*Proceedings of the Madras Government, Public Works Department,  
6th March 1874.*

No. 136. Read the following endorsement of the Inspecting Engineer for Buildings, dated Chepauk, 2nd February 1874, No. 165 :—  
From Captain A. EDGCOME, R.E., Officiating District Engineer, Bellary, to Colonel E. A. FOORD, R.E., Inspecting Engineer for Buildings, dated Camp at Pennacondah, Bellary, 1st December 1873, No. 1,438.

I HAVE the honour to submit a revised abstract estimate for Rupees 10,590, with a report, for constructing a second-class Sub-Magistrate's Cutcherry at Yemniganore, having made the needful alterations with reference to your letter No. 1,315, dated 24th October 1873. The original abstract estimate and report are also re-transmitted.

Sub Magistrates'  
Cutcherry at Yem:  
miganore - Bellary

Immigrant Cemetery  
Site Plan.

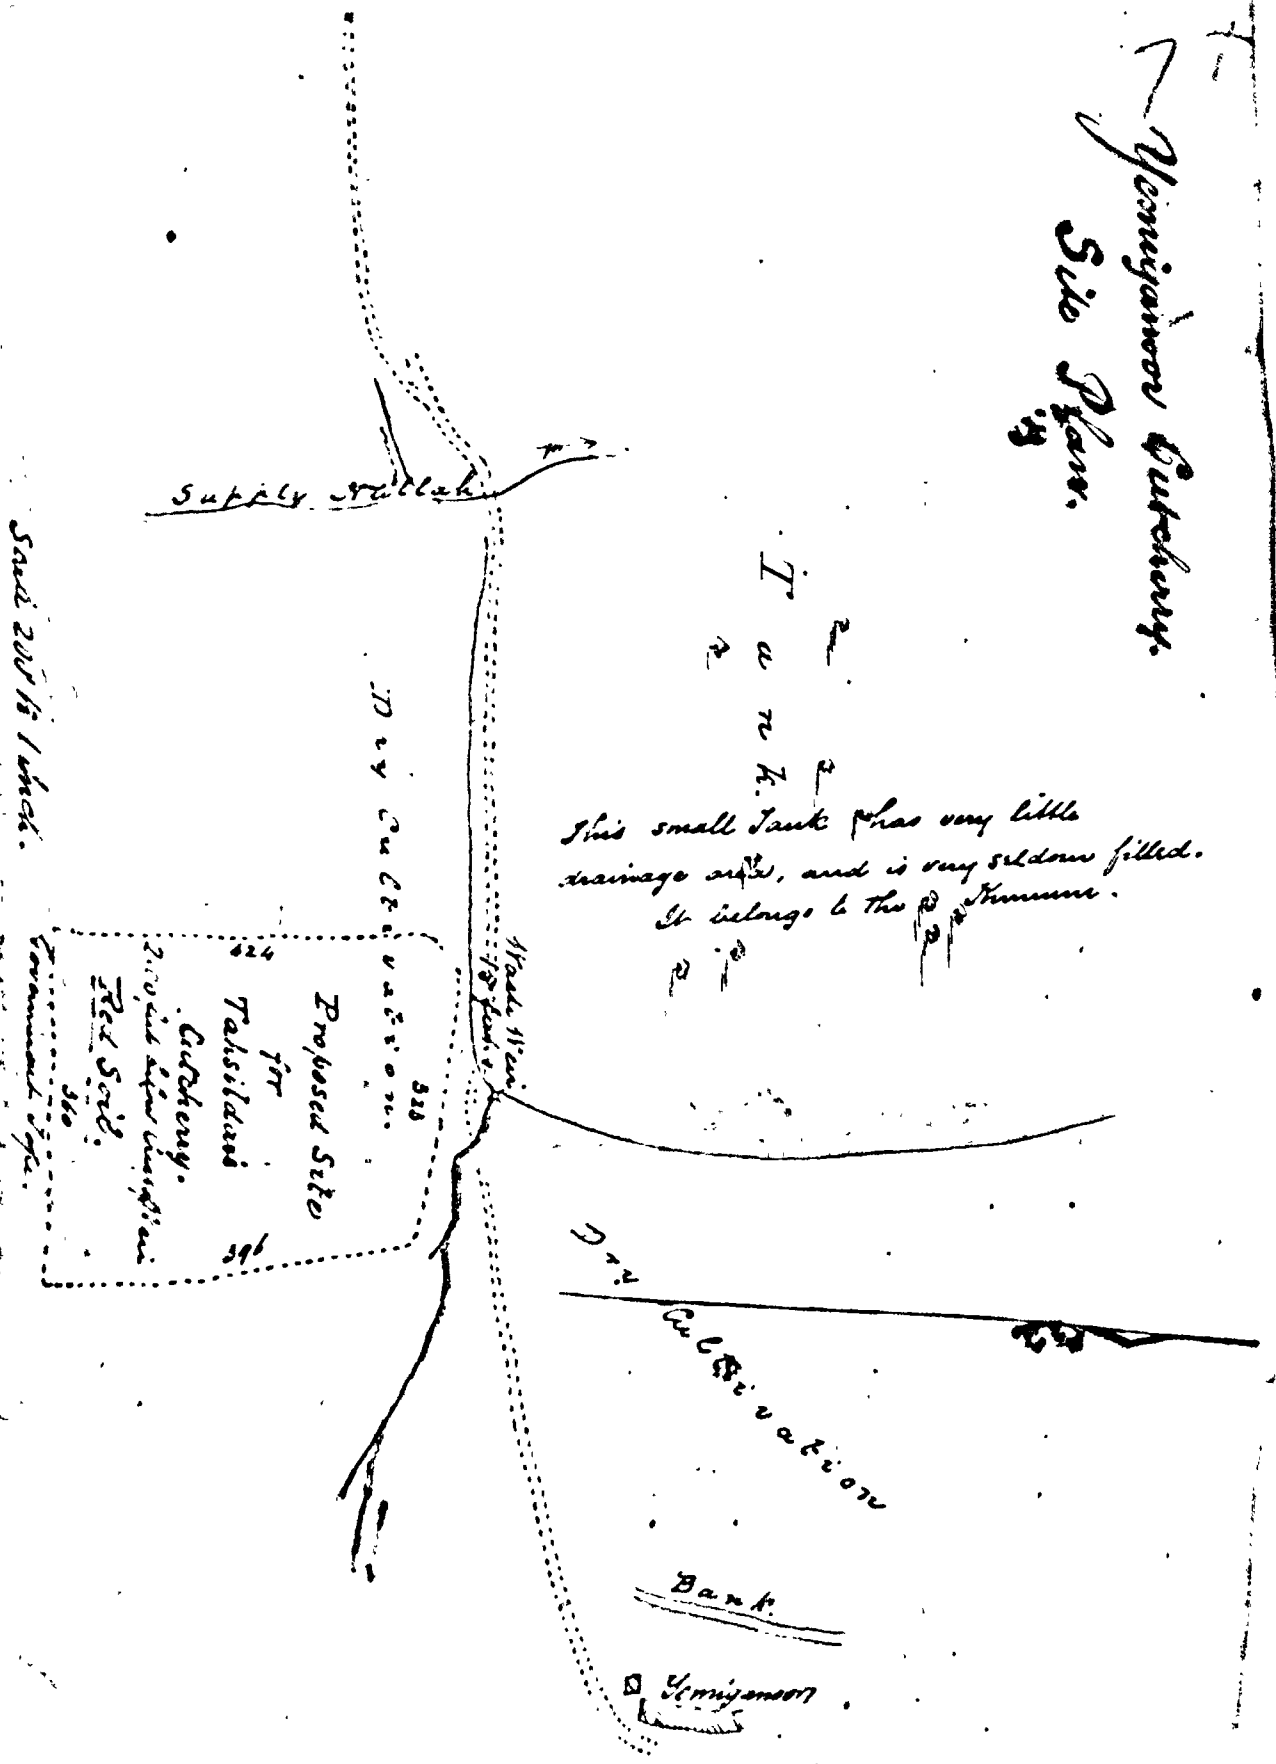
4. From the accompanying plan it will be observed that the site, which was selected by the Collector, is 2 feet below the crest of the waste weir of the small tank in the vicinity. This tank has very little drainage area, and is very seldom filled. The tail race of the weir passes clear of the selected site, and there is no objection as regards level. The Collector has promised to arrange with the owner of the tank that the crest of the waste weir shall on no account be raised above its present level.

This small tank has very little drainage area, and is very seldom filled. It belongs to the community.

5. The Collector states\* that there is no site so well adapted for the Sub-Magistrate's Cutcherry as the one now selected, and for which a sum of Rupees 210-9-0 has been sanctioned in G. O., No. 2,675, dated 1st November 1873. Necessary measures will be taken to secure the building from dampness.

there is no objection as regards level. The collector has promised to arrange with the owner of the tank that the crest of the water wall shall on no account be raised above its present level.
